SERVICE BULLETIN

M-1158

2004 SERVICE LITERATURE UPDATE

2004 Sportster Models Service Manual P.N. 99484-04

Figure 1. Refilling Front Fork Oil

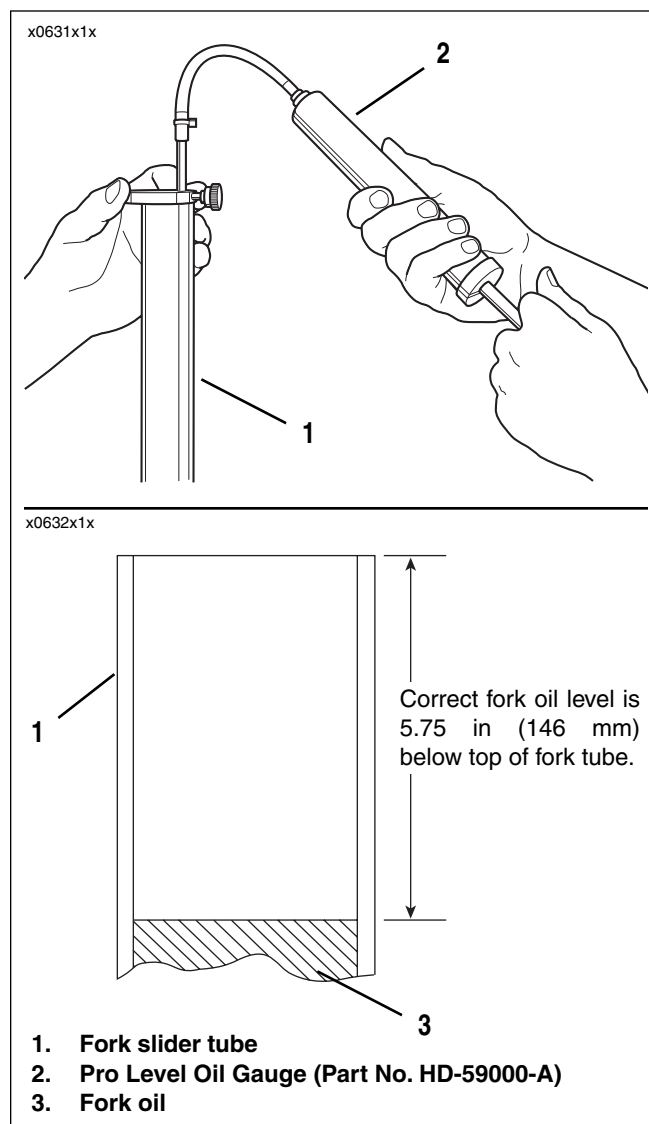
See page 1-39. Replace steps 6 through 10 of the procedure under CHANGING FORK OIL with the procedure below.

Filling Fork Oil—Forks Assembled, in Frame

2. Unscrew fork slider tube cap (1) with O-ring (2) from each slider tube (3). Replace the O-ring if damaged or worn.
3. Fill each slider tube/slider assembly with 11.6 fl oz. (342 ml) TYPE “E” HYDRAULIC FORK OIL (Part No. 99884-80).
4. Install each slider tube cap with O-ring. Tighten to 22-58 ft-lbs (29.9-78.7 Nm).
5. Lower motorcycle to the ground.

1. Position fork tube assembly upright. Remove spring and compress assembly fully.
2. Pour approximately 12 fl oz. (355 ml) Type E fork oil into fork.
3. See Figure 1. Using Pro-Level Oil Gauge (Part No. HD-59000-A), adjust oil level to 5.75 in. (146 mm).
4. Install spring and slider tube cap with O-ring. Tighten to 22-58 ft-lbs (29.9-78.7 Nm).
5. Assemble fork and install in frame.
6. Repeat this procedure for other fork tube assembly.
